## Quality Inspection Report Document number: Author: S O Brien Approved by: Date: 14/10/22 Revision: 001 Page 1 of 3

Area Issue raised:	Product description:	
Fabrication	New IP67 120mm deep	
Inspection Description:	Visual inspection	
Date:	13/10/2022

## **Punch List**

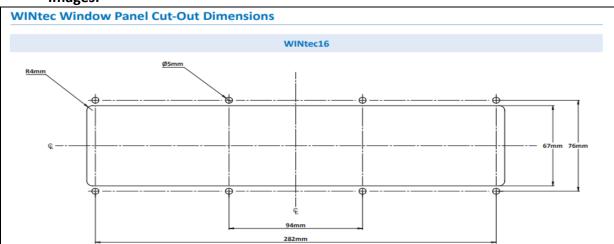
Item	Description	Action
1	Dims were updated for new overall size however the features in the enclosure e.g. weld studs, were not increased to match offset of new size.	Update features of model
2	Hole locations were based on old data card from previous supplier.	New data card sourced and provided to engineering. Model in question is type 16. Recommended to convert holes to slots to allow for the use of old and new window types.
3	Door on pillar unit cannot close, brackets to be drilled to allow enclosure to sit lower in unit.	New enclosure should have been remodelled in assembly to check for fitment issues. Update and remodel before making new standard item.
